Memo to File (GE Water Reactors)

DRL/GE MEETING ON MEANS TO CONTROL COMBUSTIBLE GASES FOLLOWING A LOCA,
AUGUST 13, 1971, BETHESDA, MARYLAND

Purpose: GE requested this meeting to discuss a proposed means to control H₂ buildup following a LOCA for those seven plants where GE has the back-fit responsibility (Oyster Creek, Millstone, Monticello, Dresden 2 and 3 and Quad Cities 1 and 2).

ADDITIONAL FILTER

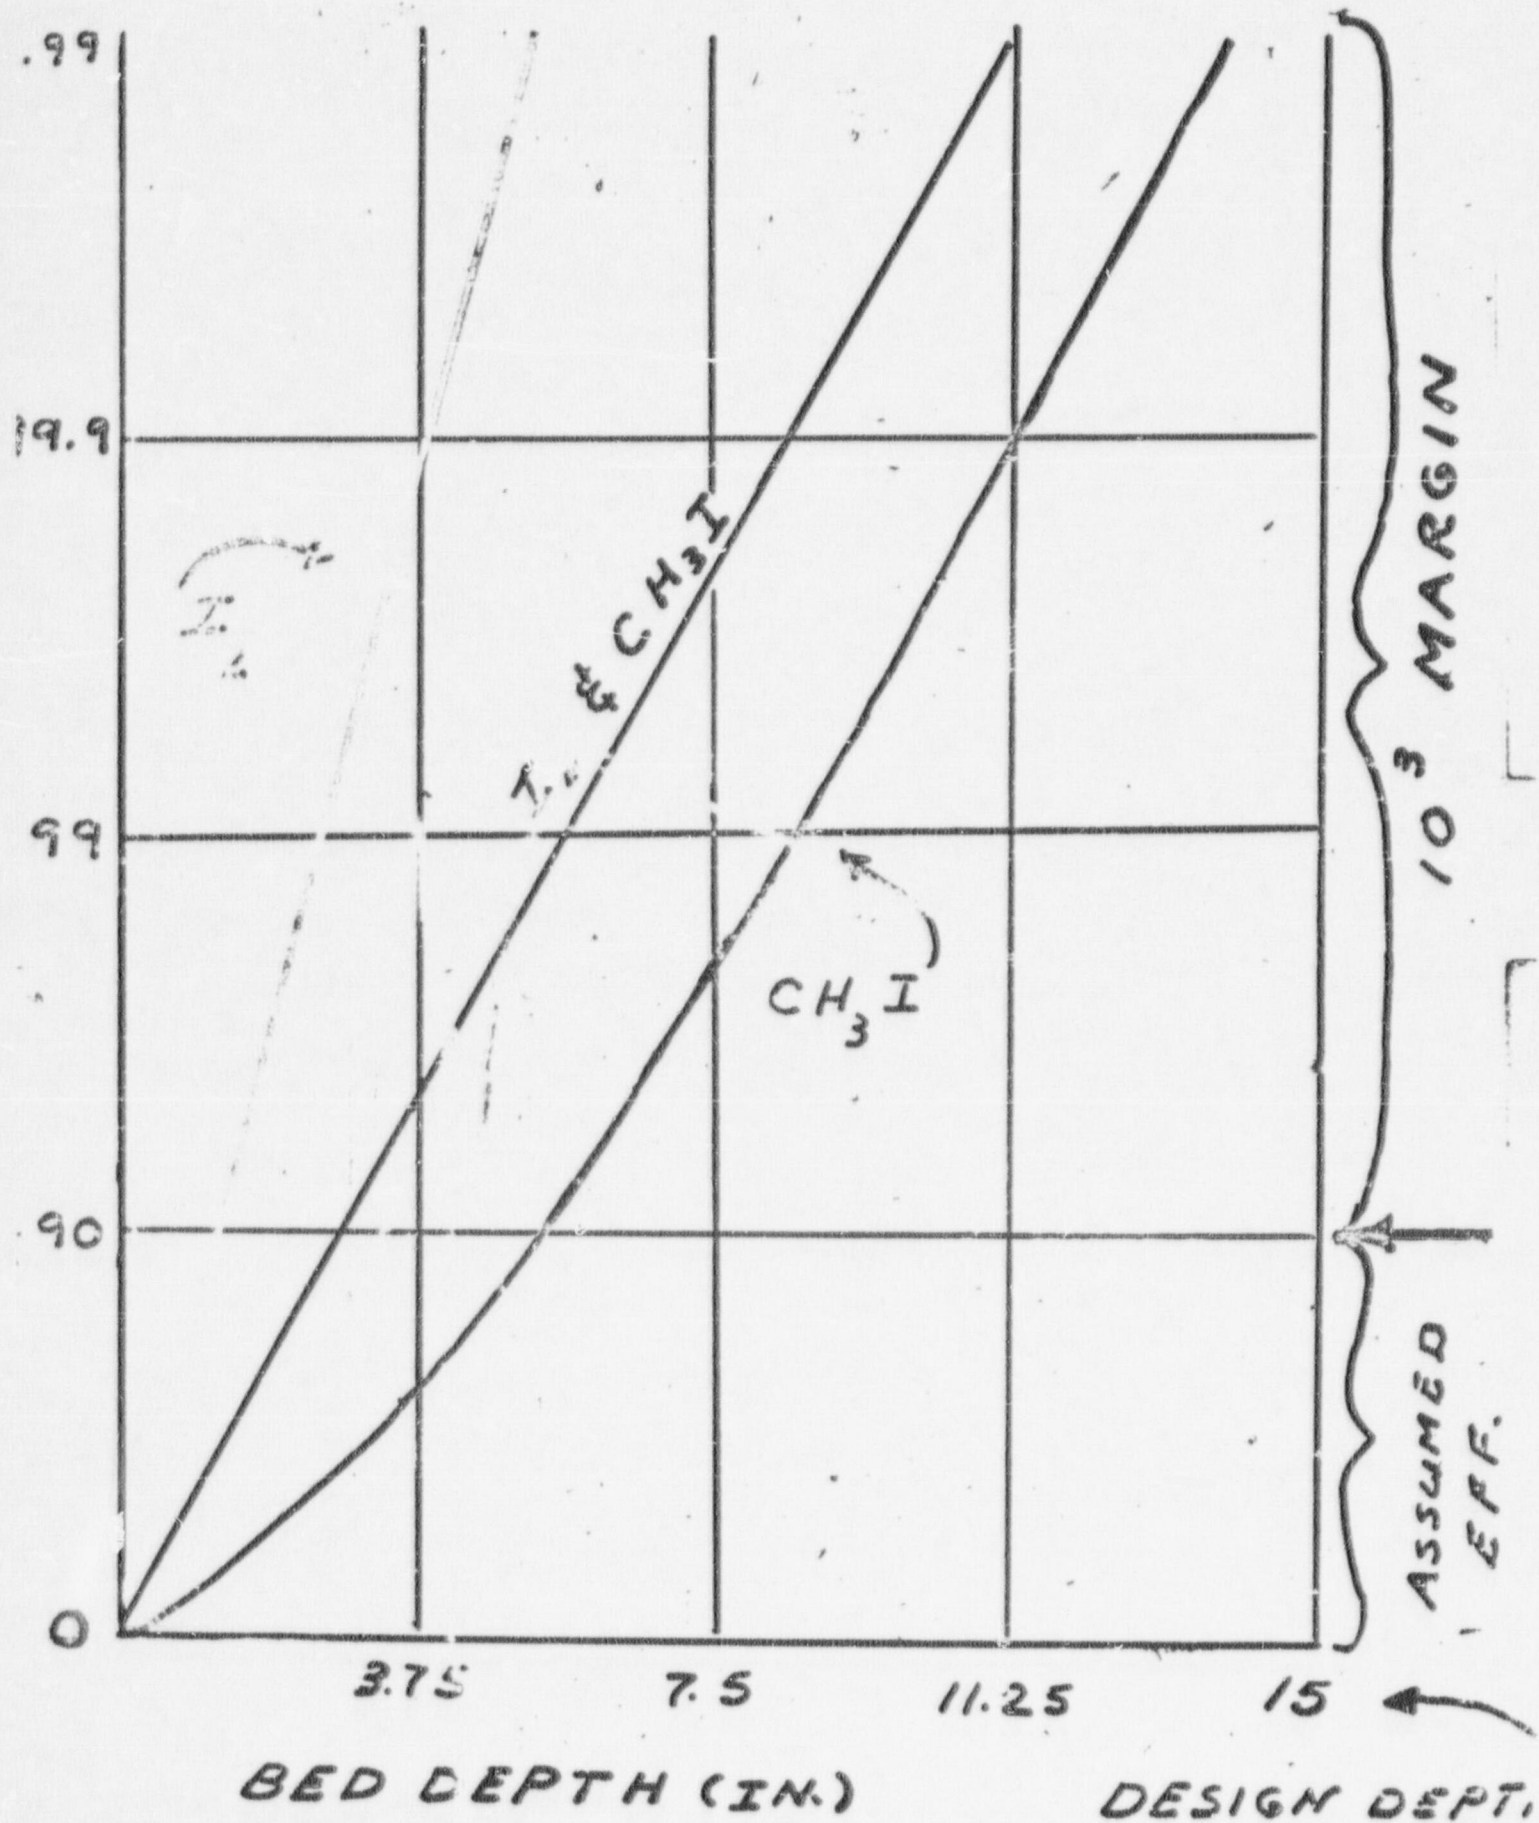
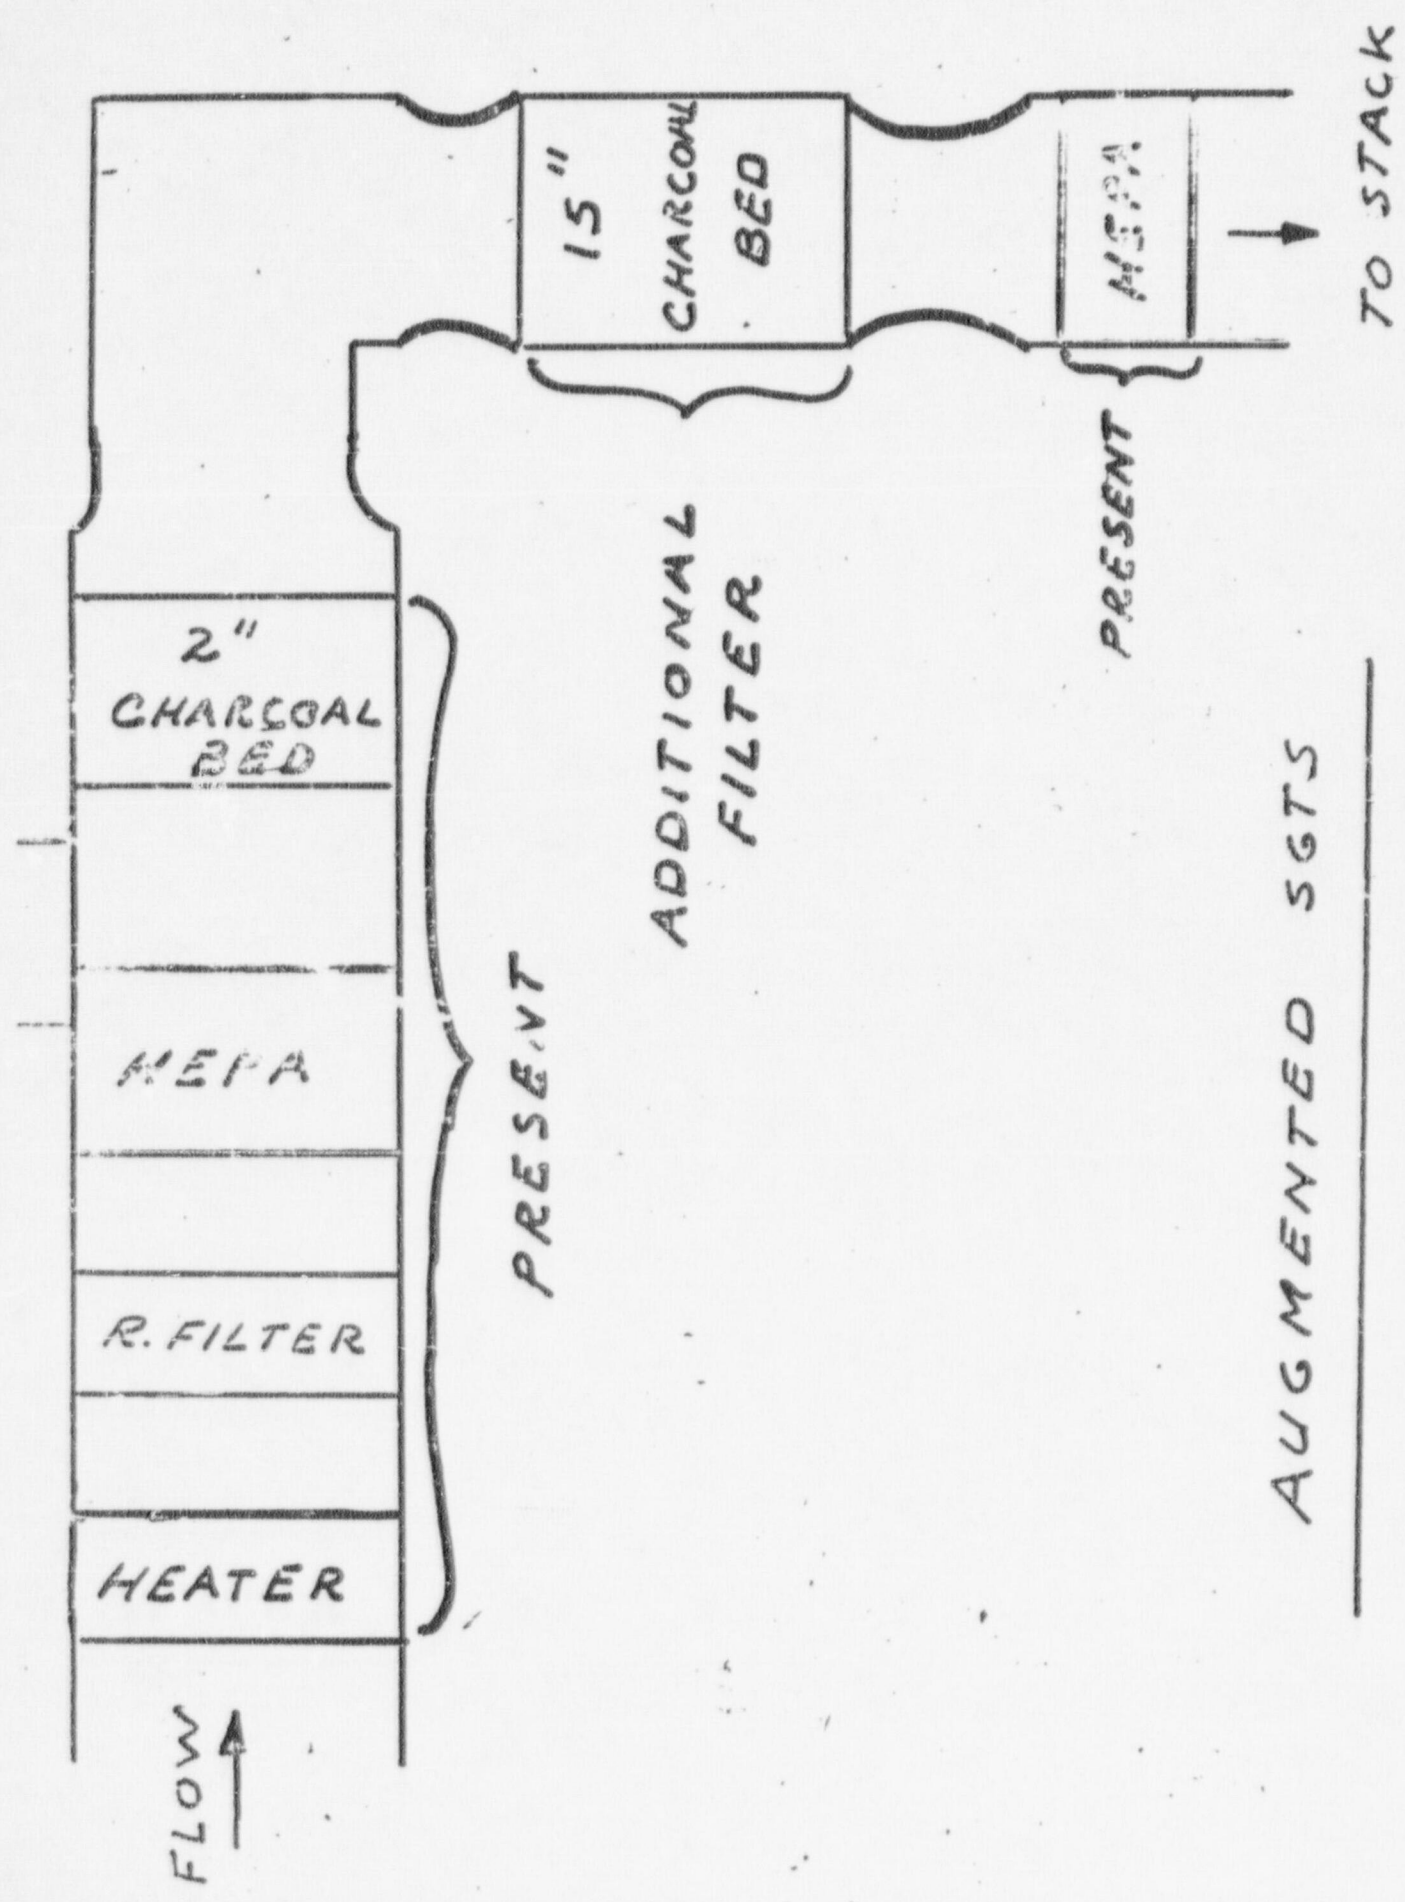
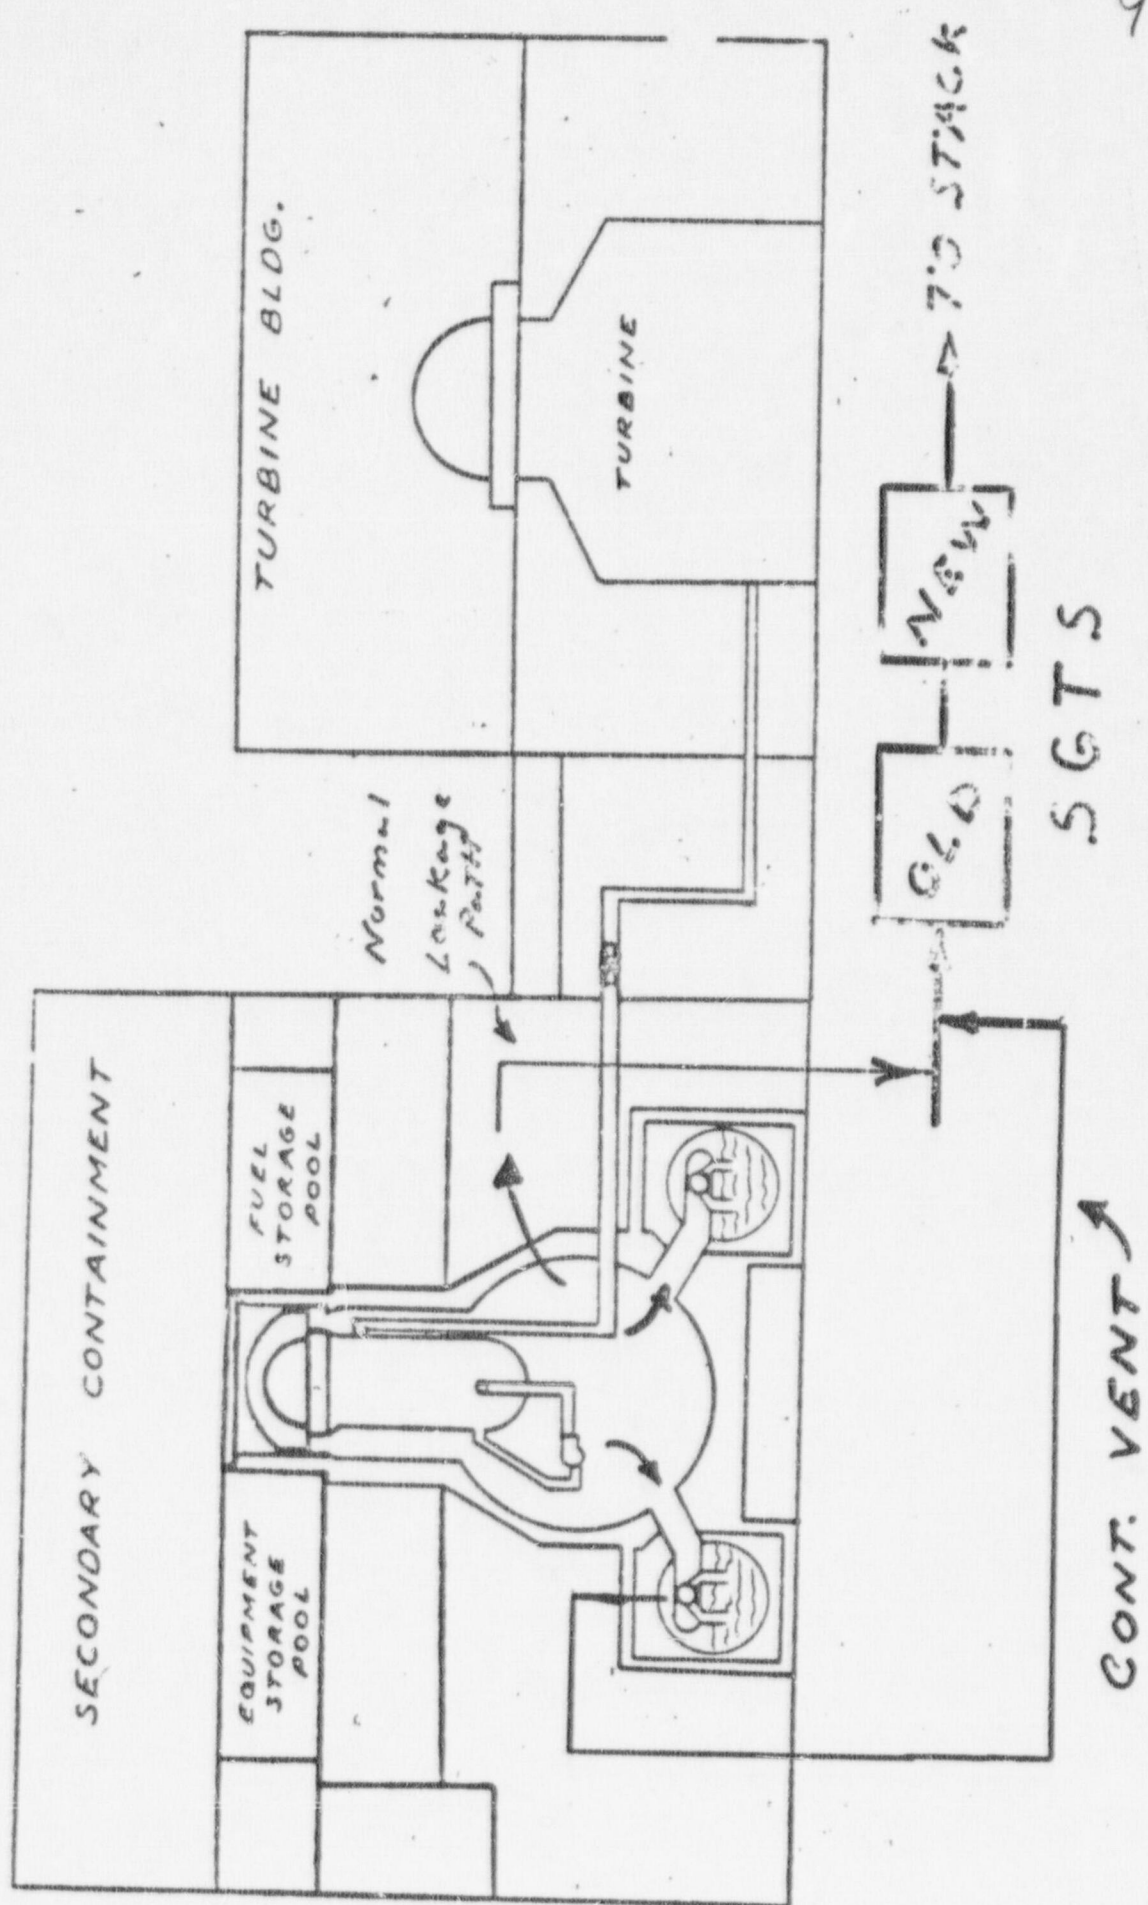
Q - How will the filter be tested periodically? Its large size may present a problem

Q - Channeling may be a problem in this "pancake" design.
How will channeling be precluded?

Q - What means will be provided to prevent a charcoal fire?

A - The Freon test presently in use for charcoal filters would probably be used.

A - Channeling has not been a problem in the filter tests
conducted to date.

A - Water spray/cooling will have to be provided.
